**Town of Duanesburg
Zoning Board of Appeals
August 16th, 2022**

PROPOSED SITE PLAN FOR
OAK HILL SOLAR 1&2
APPLICANT:
OAK HILL SOLAR 1, LLC & OAK HILL SOLAR 2, LLC
13950 DUANESBURG ROAD
TOWN OF DUANESBURG, SCHENECTADY COUNTY, NEW YORK

Exhibit B Biggs/Bruning to Zoning Board June 20, 2022

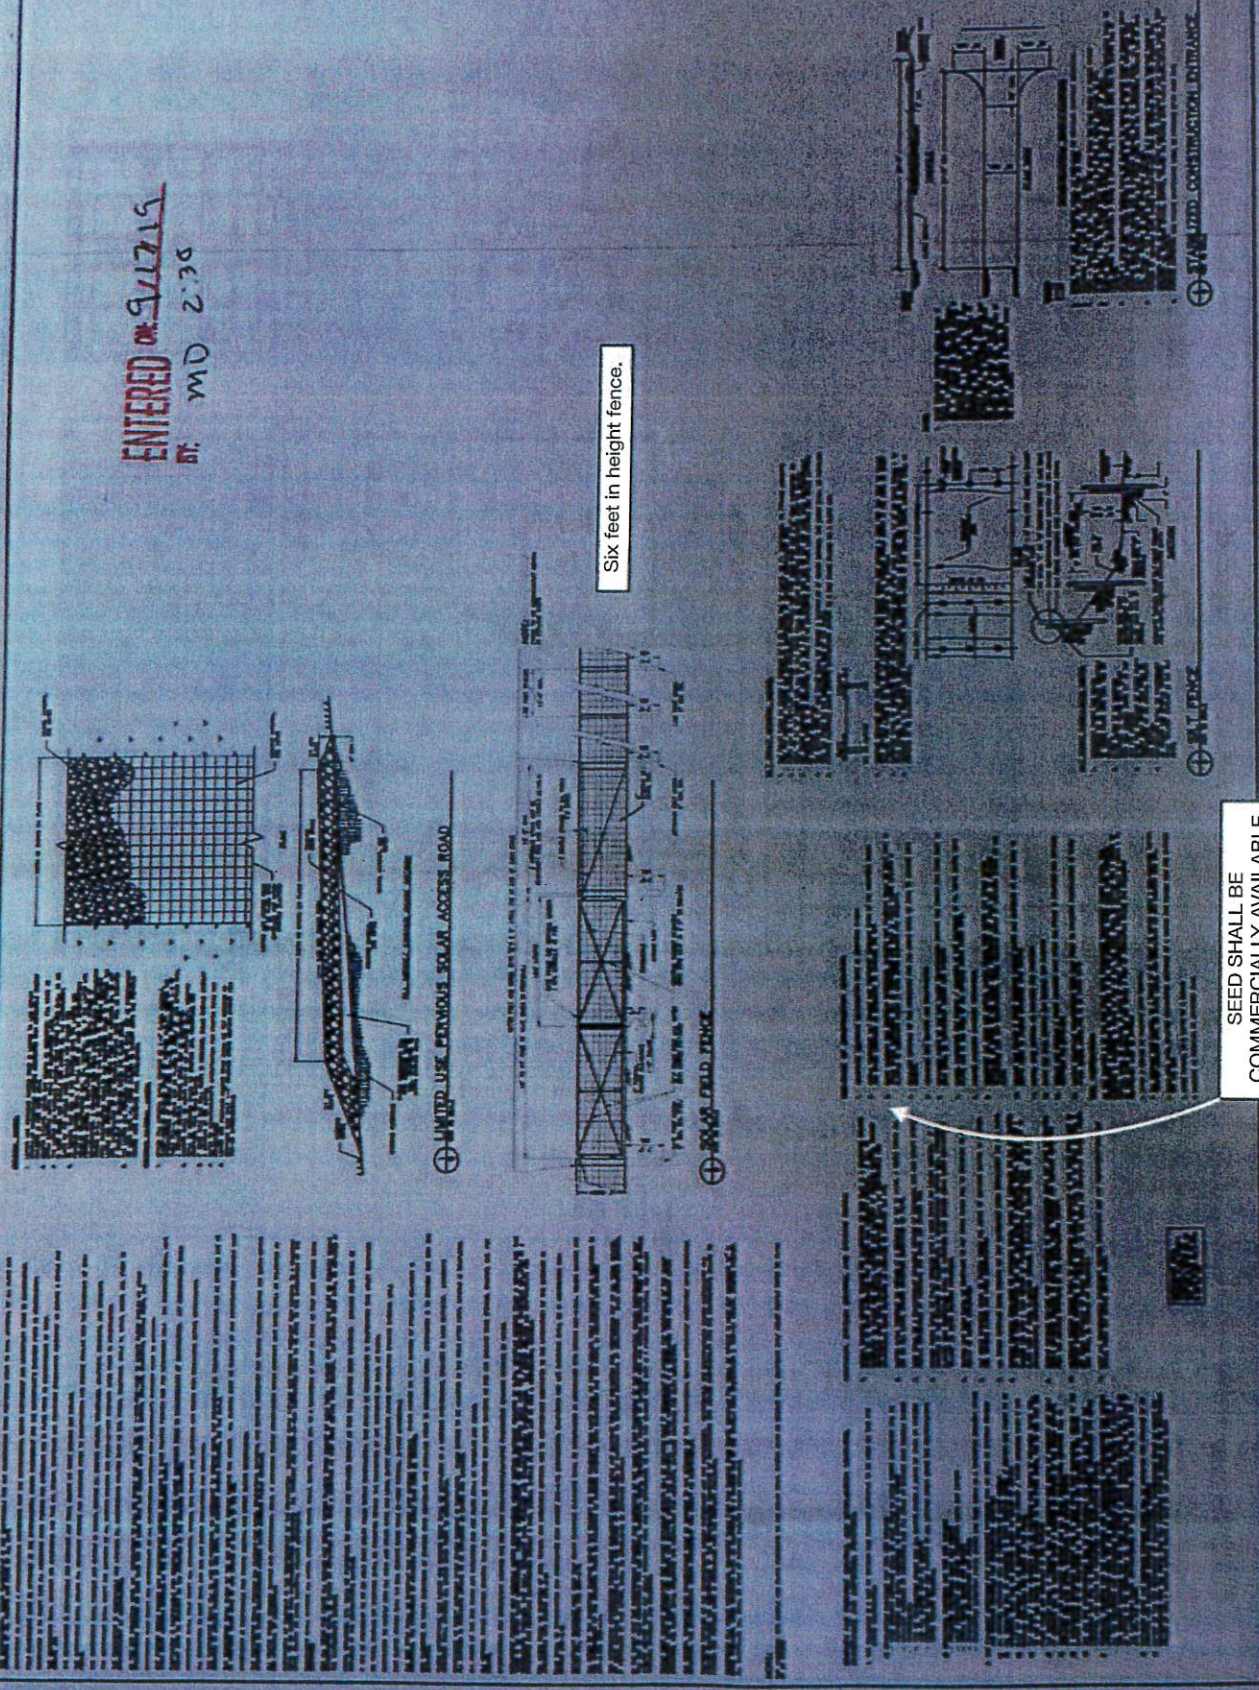
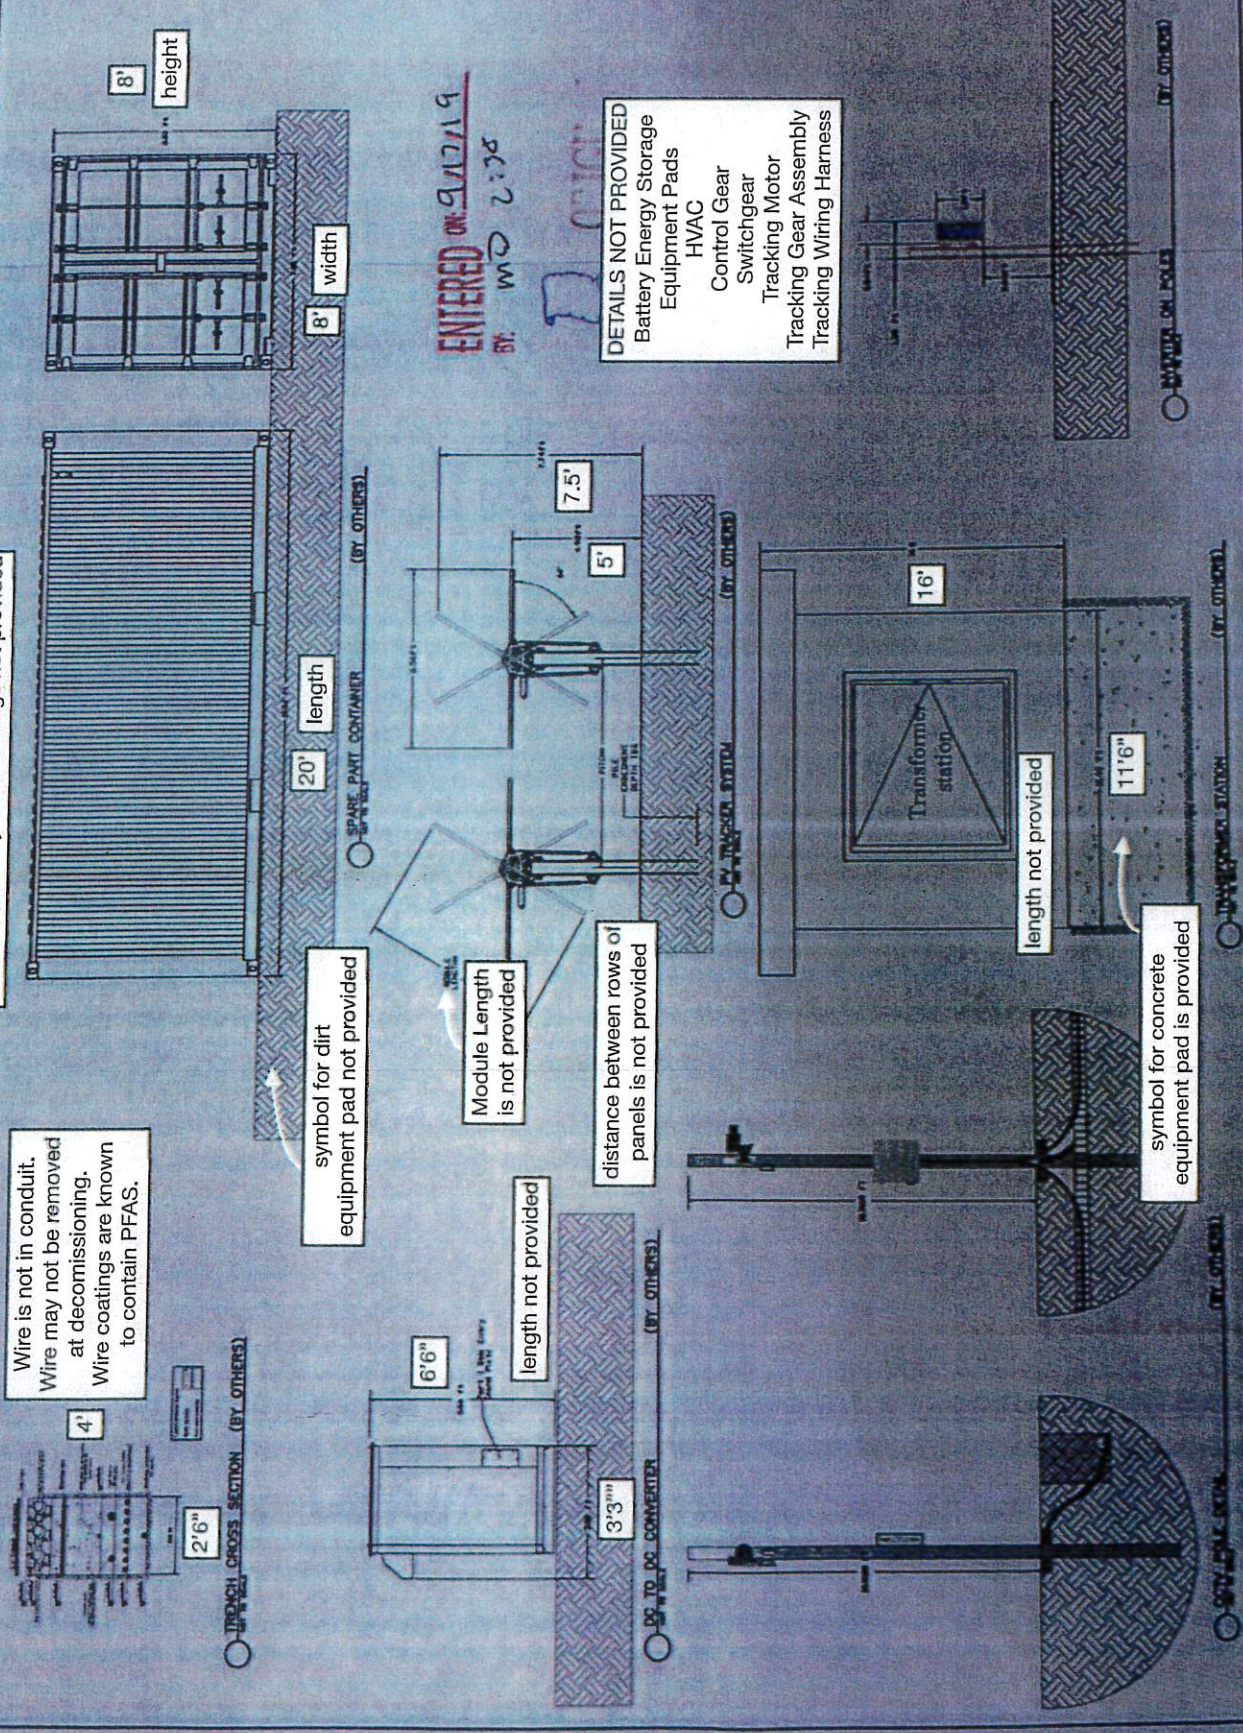
Wire is not in conduit.
 Wire may not be removed
 at decommissioning.
 Wire coatings are known
 to contain PFAS.
